Agenda Item 3
710 Green Briar Lane
Revisions to Previously Approved Plans

Consideration of a request for revisions to previously approved plans for a new residence on a vacant lot.

The property owner now wishes to proceed with development of the property, with a modified plan. The owner submitted modified plans for permit and after review, staff determined that the changes made were significant enough to require further Board review. The reason for the modified plan based on information from the petitioner, is to reduce the amount of second floor living space and by doing so, reduce the cost of construction. The project is now moving forward, with a new architect and civil engineer. The architect who originally designed the house is no longer involved with the project. The request now before the Board seeks approval of changes including changes to the footprint of the residence, the overall massing and roof forms.

Review of Proposed Changes and Comparison to the Previously Approved Plan

FRONT ELEVATION

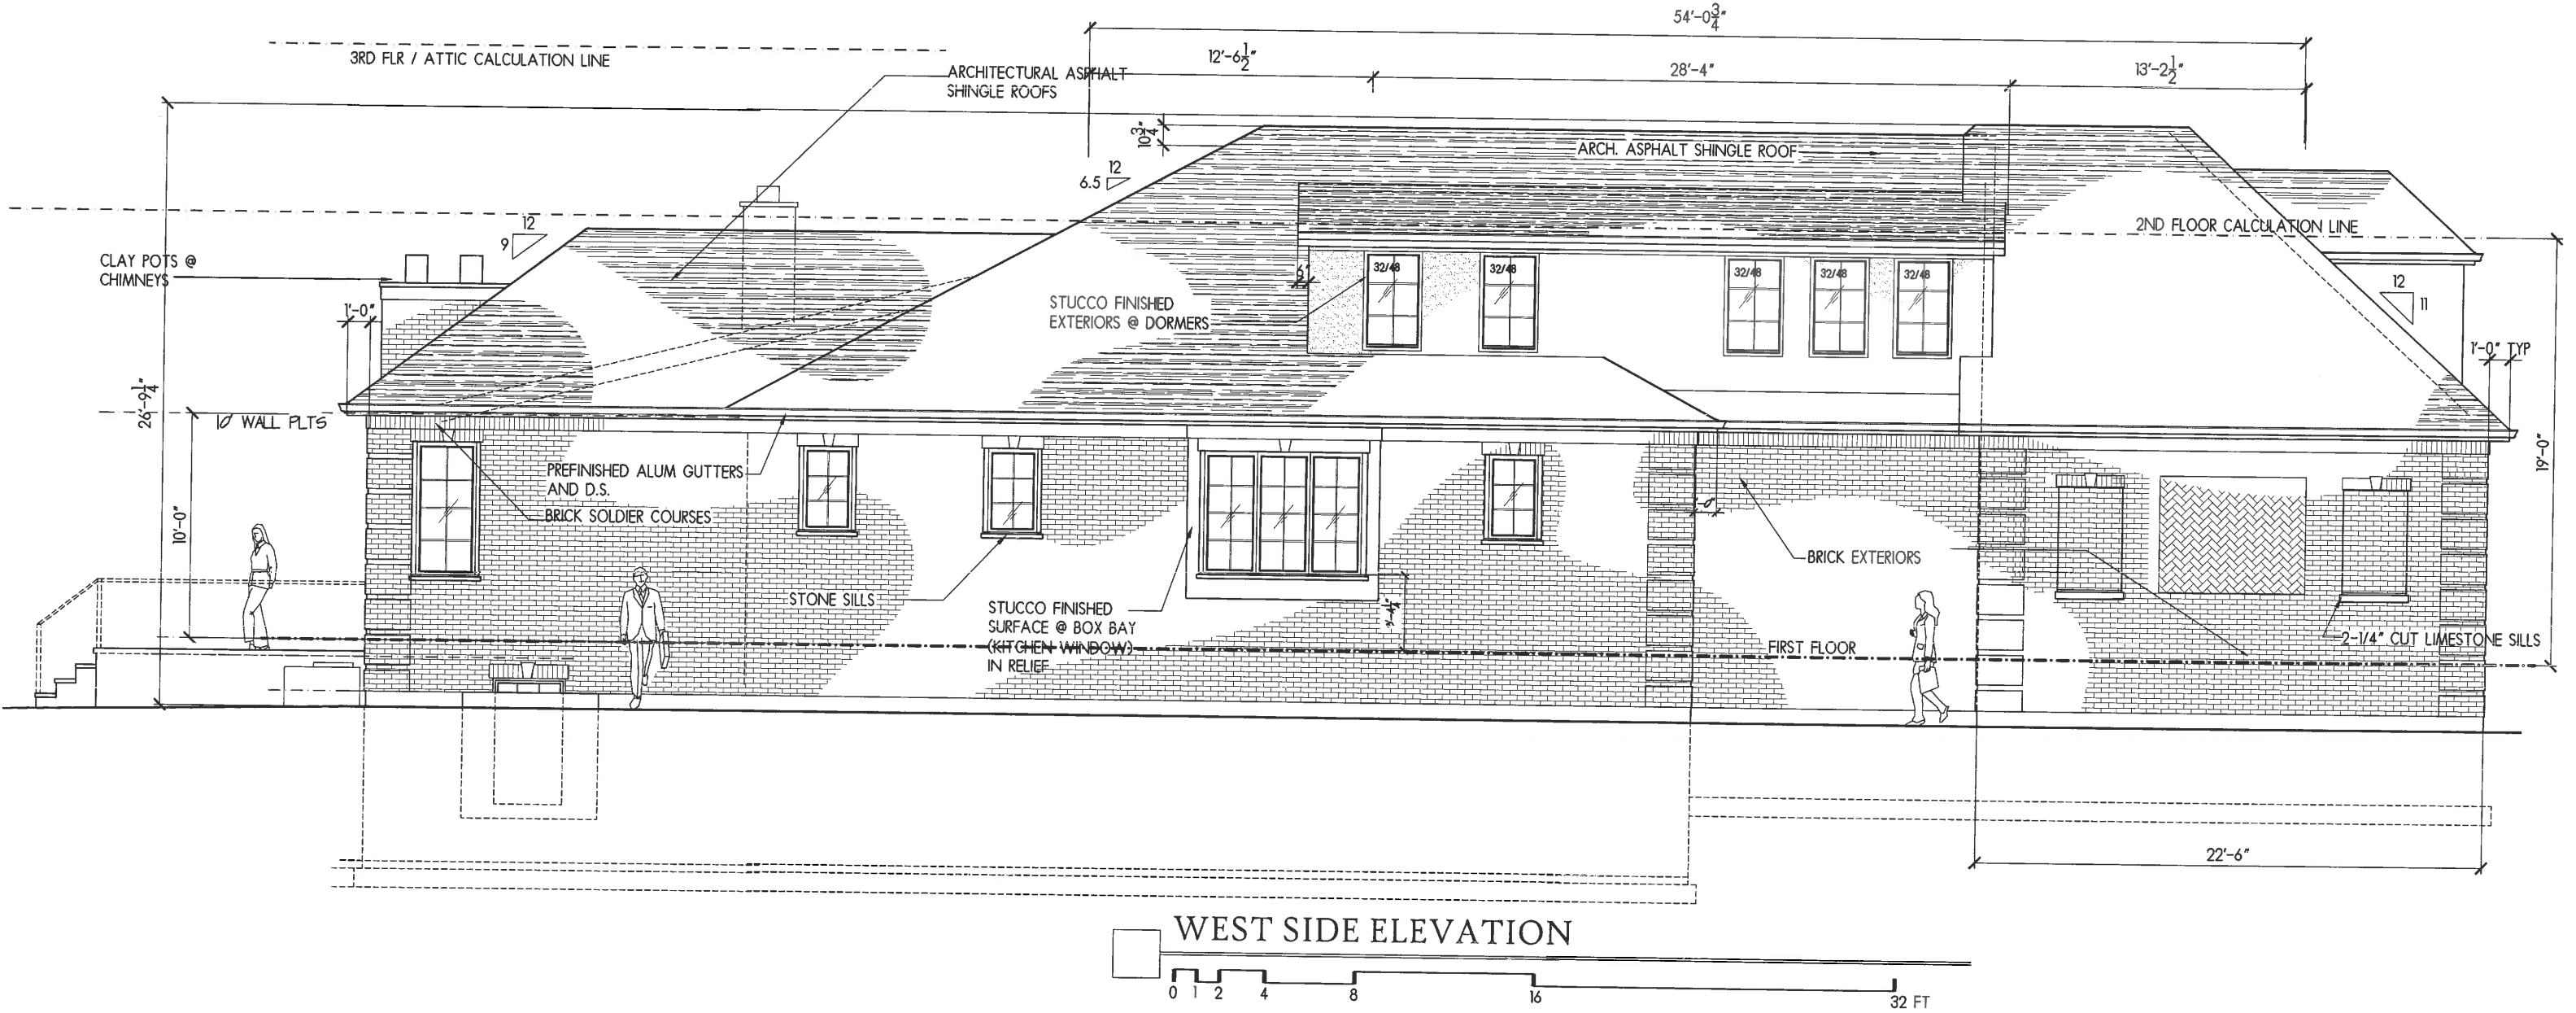
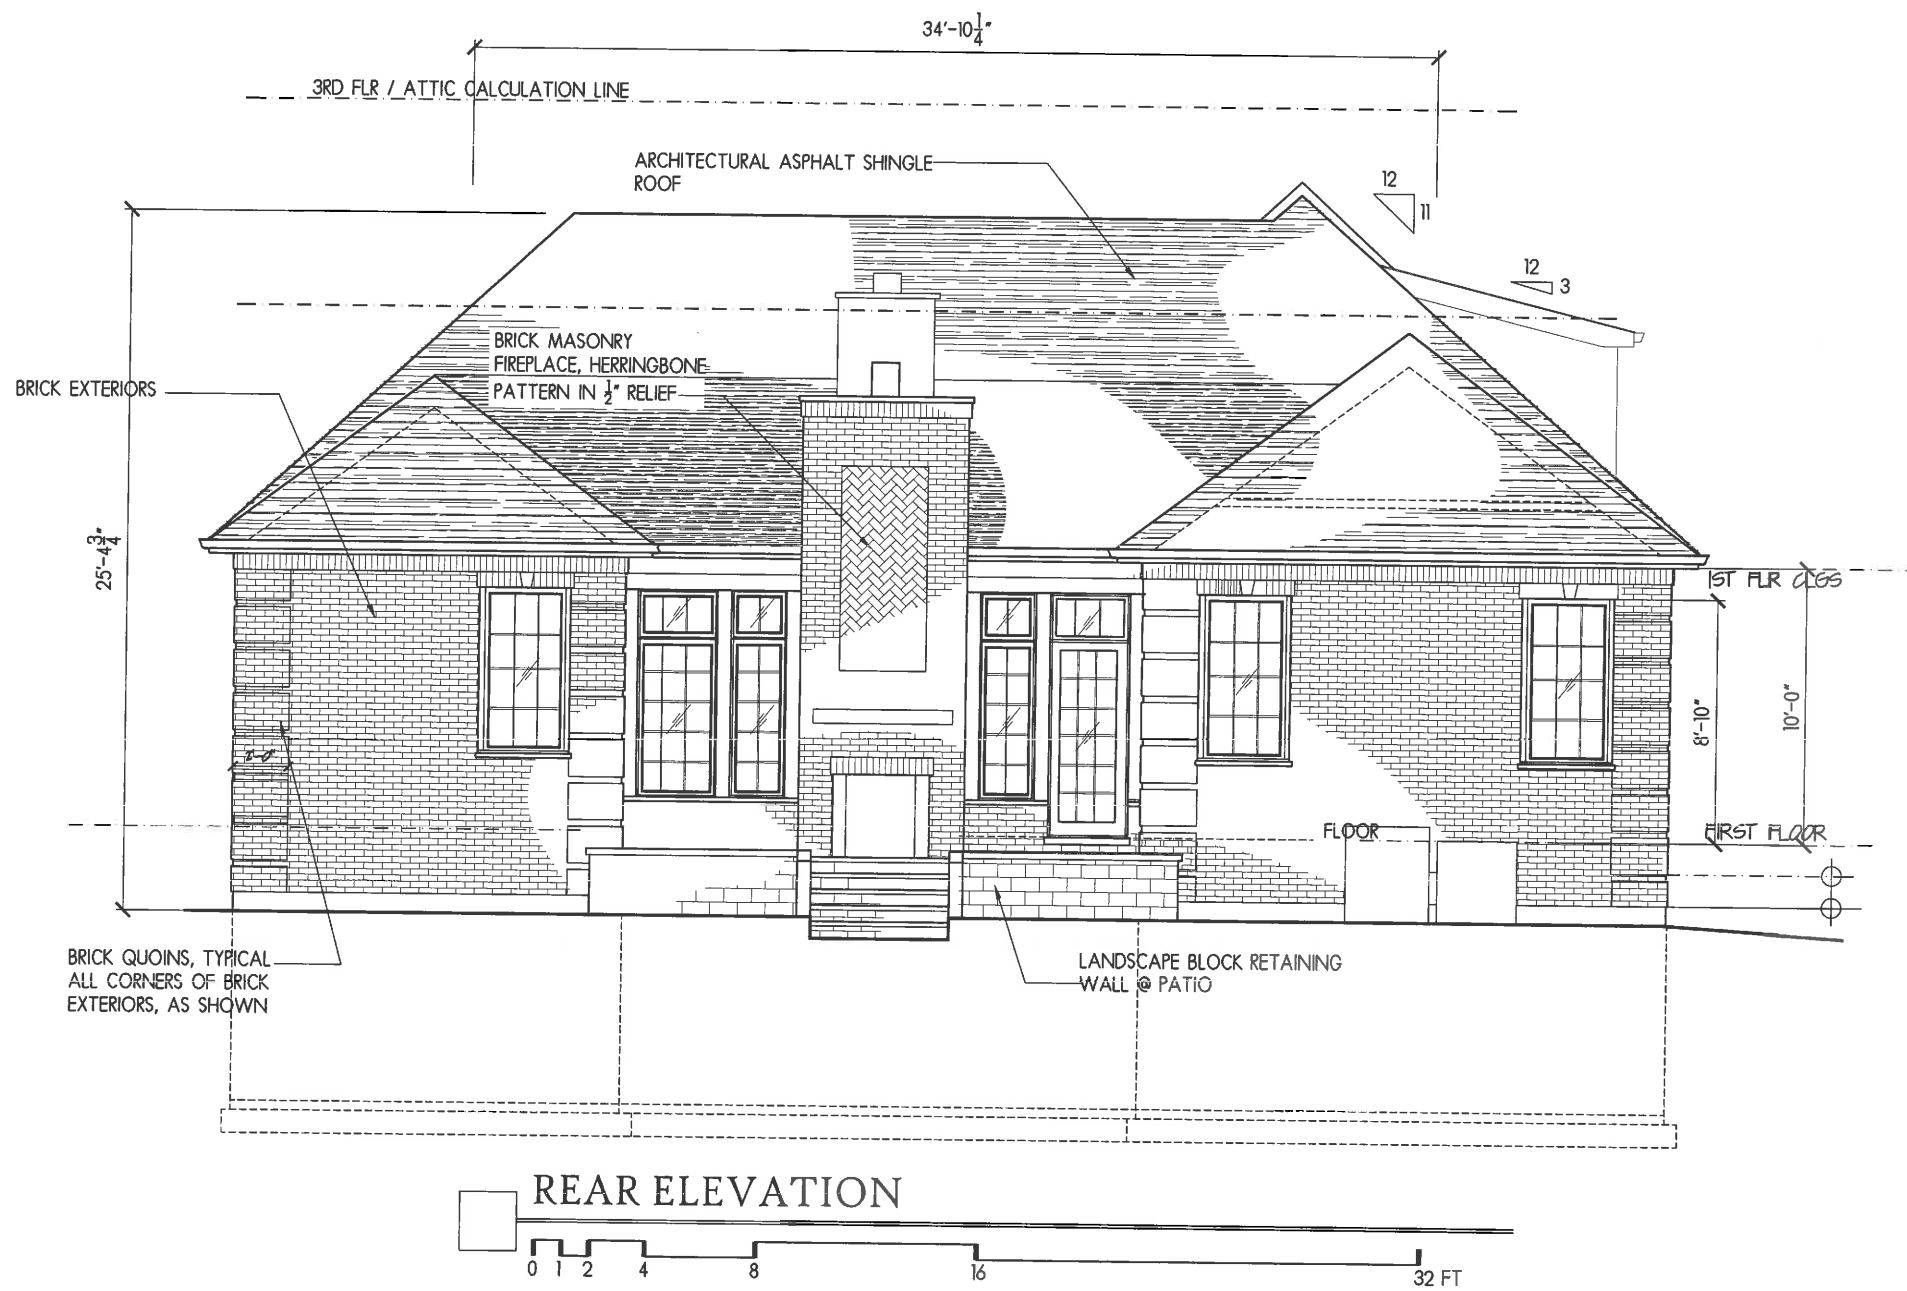
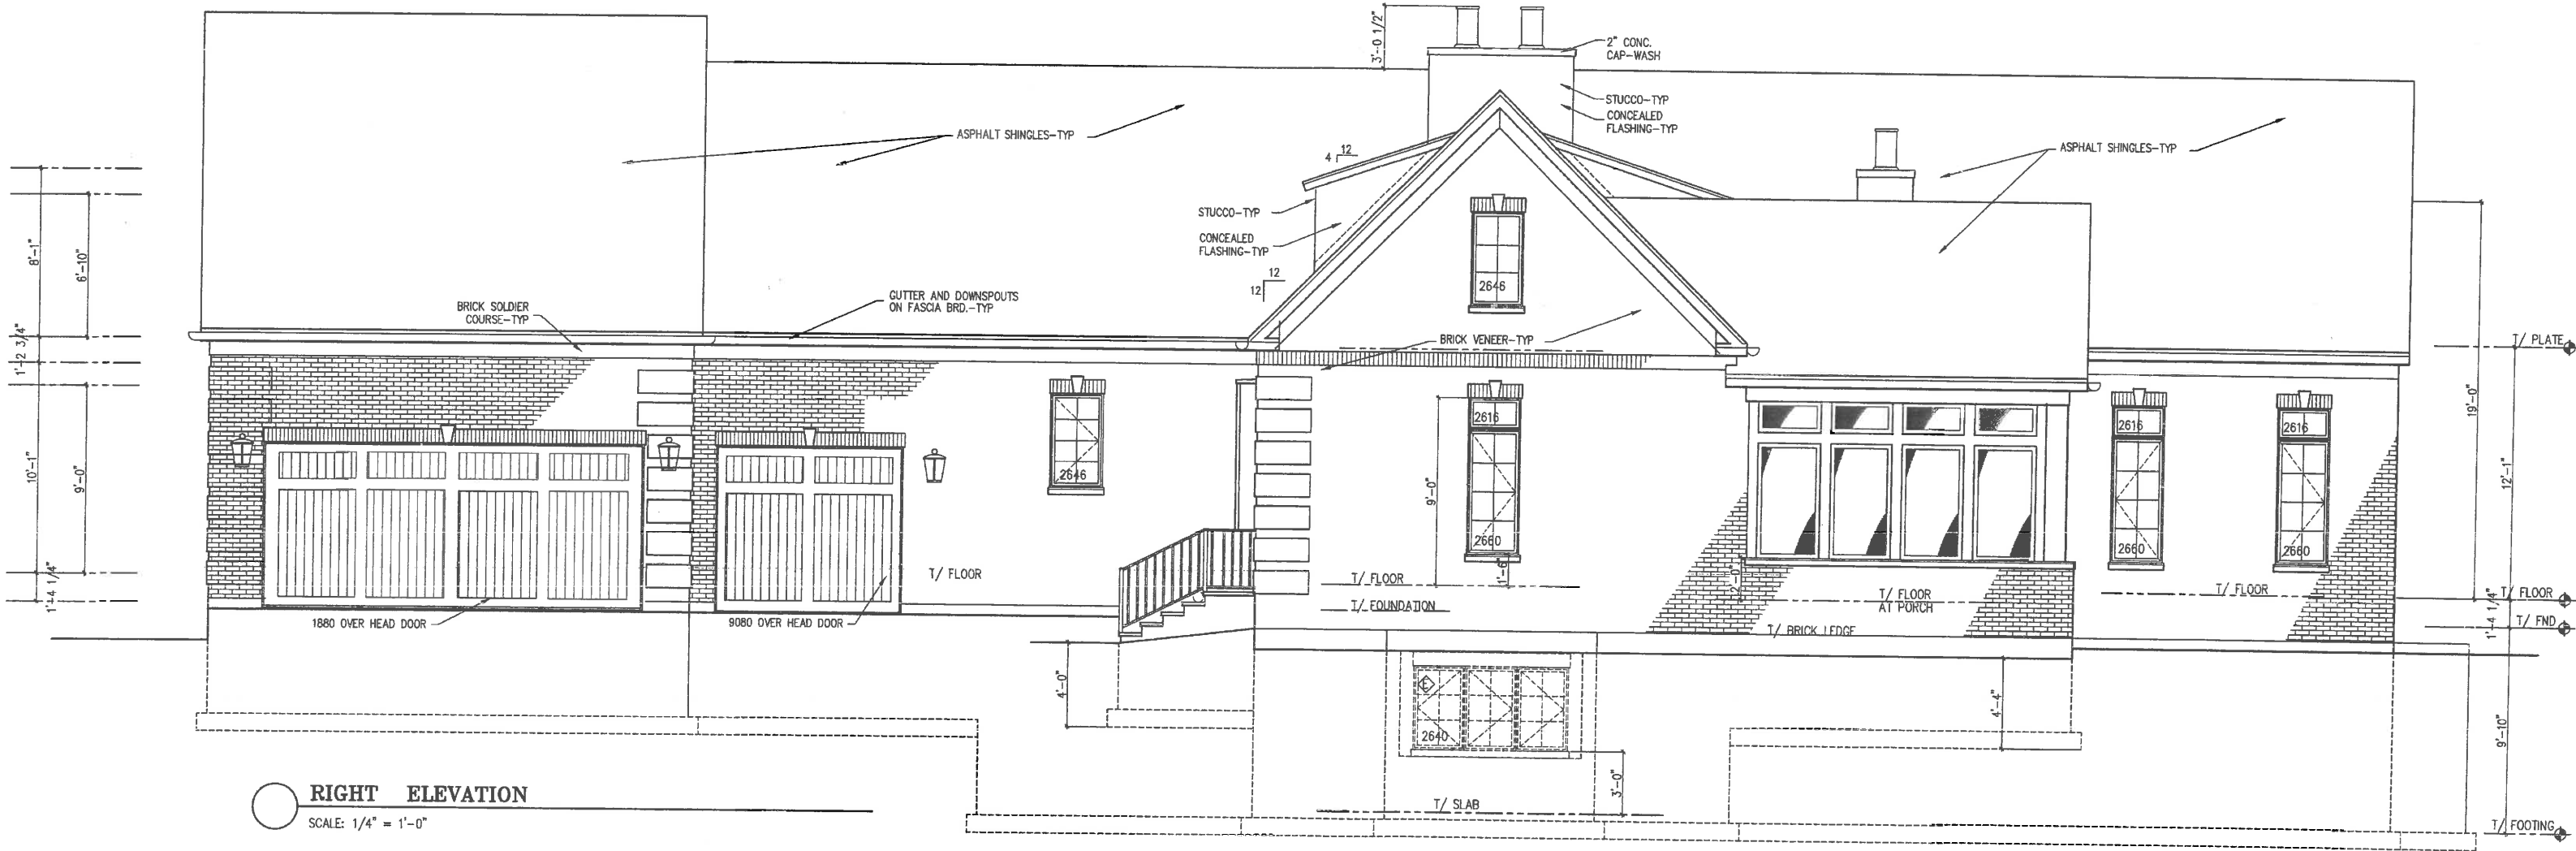
- Hip roof forms are now proposed on the garage mass and on the main mass of the residence to replace the previously proposed gable roof forms.
 - As currently proposed, the proportions of the hip roofs appear squat. The previously approved gable roof forms appeared more in keeping with the style, scale and proportions of the house. Board input on the hip roof forms is requested.
- A hip dormer with a double window is now proposed above the garage.
- One of the shed dormers was removed and a single dormer is now proposed on the main roof form and centered between the windows below.
- The detailing and proportions of the front entry door surround were modified.
- The proportions of the windows on the garage mass were modified.

- The overall width of the structure is reduced (wall to wall and eave to eave), the new design providing for a more consistent treatment of gutters and eave conditions and a proper soffit/overhang
- Former front-facing 'gable' roof, now designed as a hip roof, with a shallower slope (11/12) versus 13/12
- Front-facing mass reduced; flat façade at the front of the garage with double-window at the second floor, now presented as a dormer
- Main roof, behind, simplified with a single shed dormer as opposed to two
- Overall height – reduced – from 30'-1" down to 26'-9 1/4"

- East and west massings, formerly 'gable faces' in the cross-roof direction, extending to the north and south, were previously visually apparent front-wards; this new design converts those side-roof plans to 'hips,' thus eliminating the mass-gable facades (east and west) entirely
- Main roof: former protruding 'chimney' somewhat in line with the front door, is also removed entirely

PREVIOUSLY APPROVED WEST ELEVATION

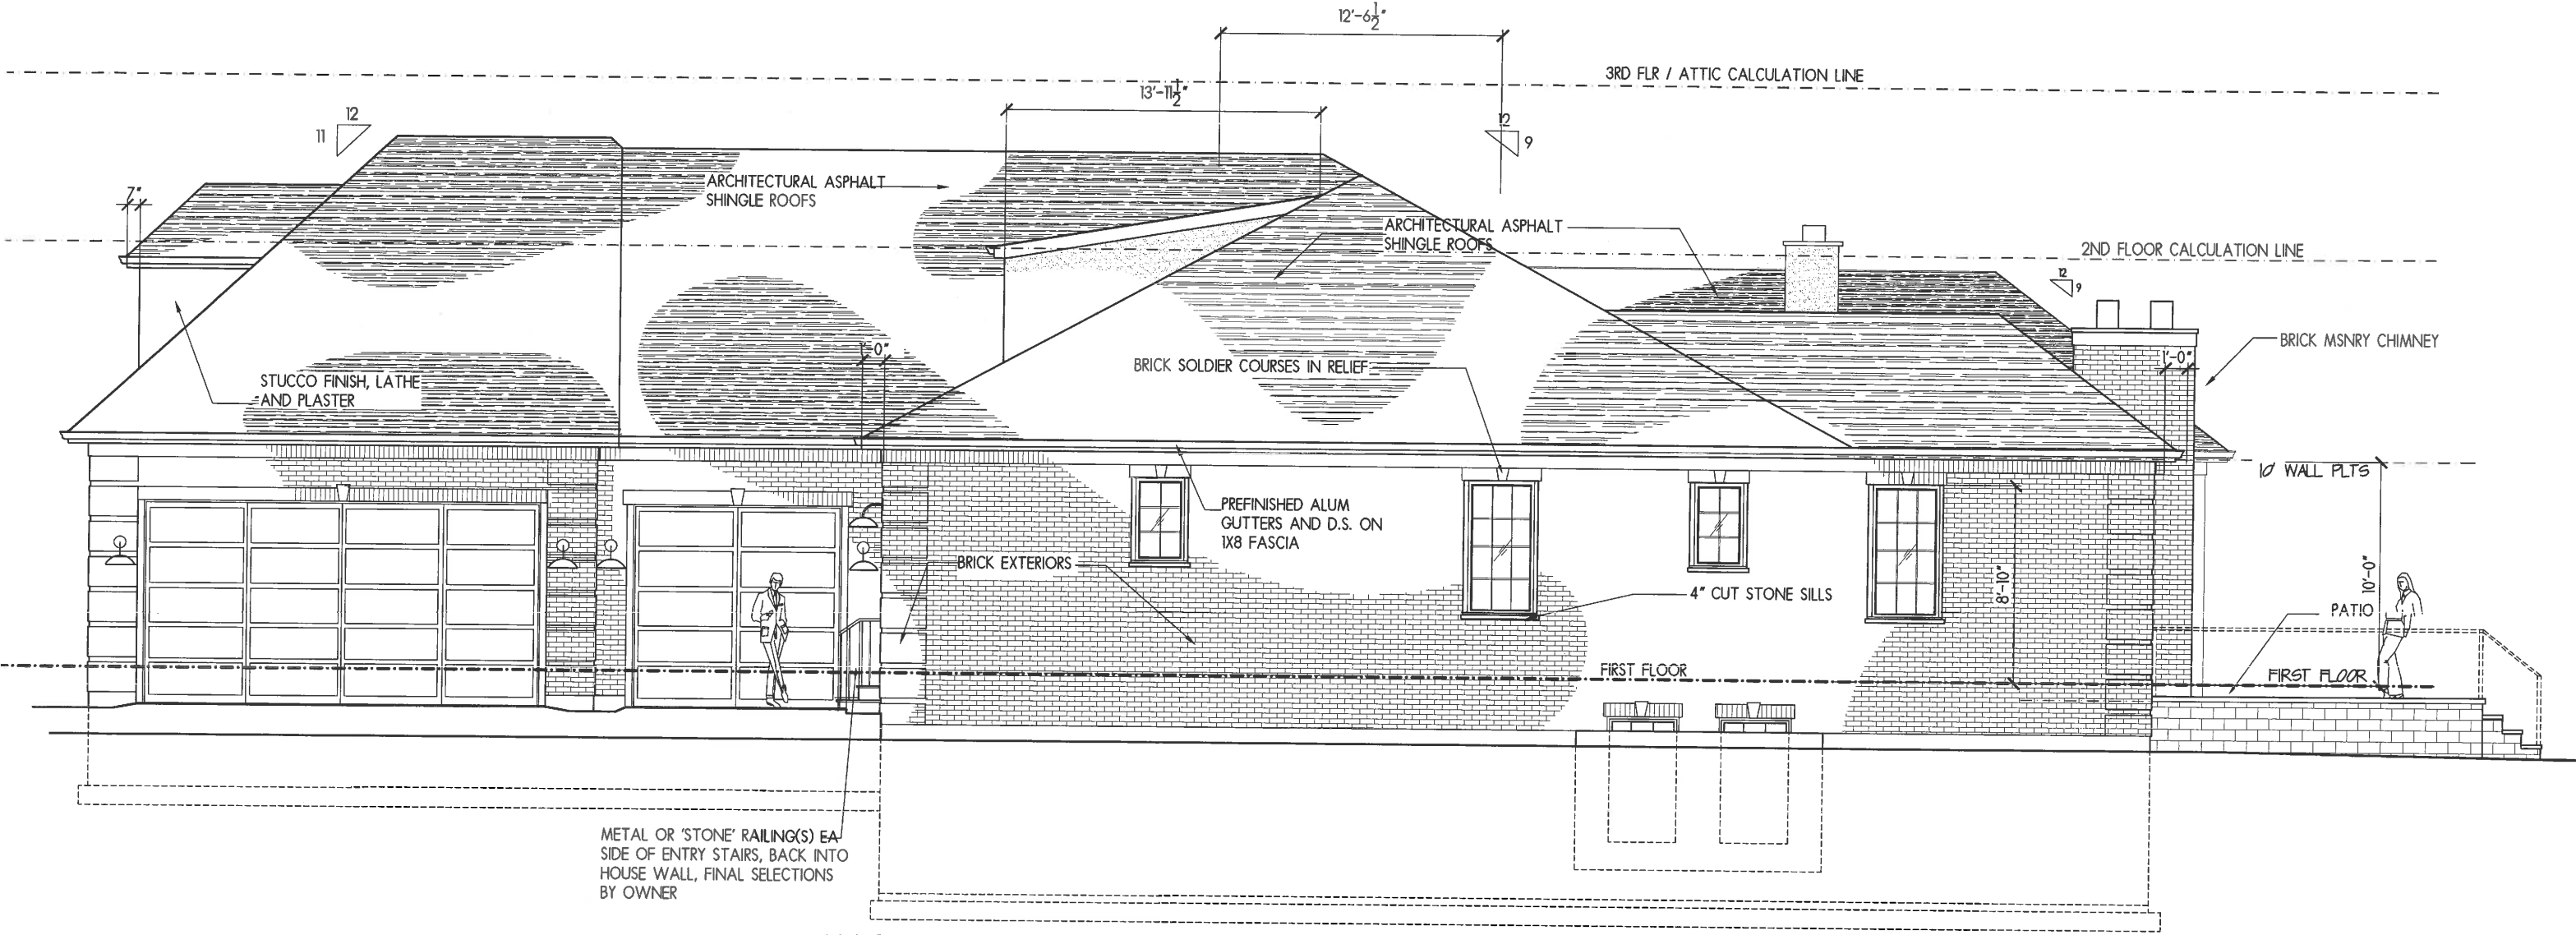
- The central gable element was removed from the elevation.
- The roof form on the west elevation presents multiple roof lines and pitches. The hip roof at the south end is an 11:12 pitch, the central hip roof is a 10.5:12 pitch, and the hip roof on the north end is a 9:12 pitch.
- One long shed dormer is now proposed instead of the two previously approved shed dormers on the elevation.
 - As currently proposed the shed dormer as it relates to the larger roof form appears complex. Board input on the proposed shed dormer is requested.
- The placement and proportions of the windows was modified.

- Again, as in the east elevation, the depth of the home is reduced by almost 12, thus 'increasing' open yard space behind the home and less impacting topography
- Main roof: de-massed by virtue of transitioning from gable-roofs all around to hip roofs

- Formerly a 'mix' of shed dormers and a single large-scale gable element extending forwards, now presented as a single shed dormer with a consistent window theme
- North wing, on the left of the façade, improved window composition with a better proportion of window (void) to brick (mass) than formerly presented

Board member Walther suggested that the west elevation could be softened with the addition of openings or a raised brick detail shown on other elevations of the house.

Chairman Notz agreed that the raised brick detail or an alternate brick pattern would be an acceptable solution to address the unbroken expanse of wall on the west elevation without adding windows. Hearing no further questions from the Board, Chairman Notz invited public comments.

1. The west elevation shall be revised to add detailing to break up the long, unbroken wall.
2. Any further modifications made to the plans as a result of final design development or in response to comments offered during the Board's review shall be clearly called out as part of the submittal for building permit. A copy of the plans as submitted to the Board for review shall accompany the plans submitted for permit and areas of change shall be highlighted in some manner. Staff is directed to review any changes, in consultation with the Chairman as appropriate, to determine whether the modifications are in conformance with the Board's direction and approval prior to the issuance of any permits.
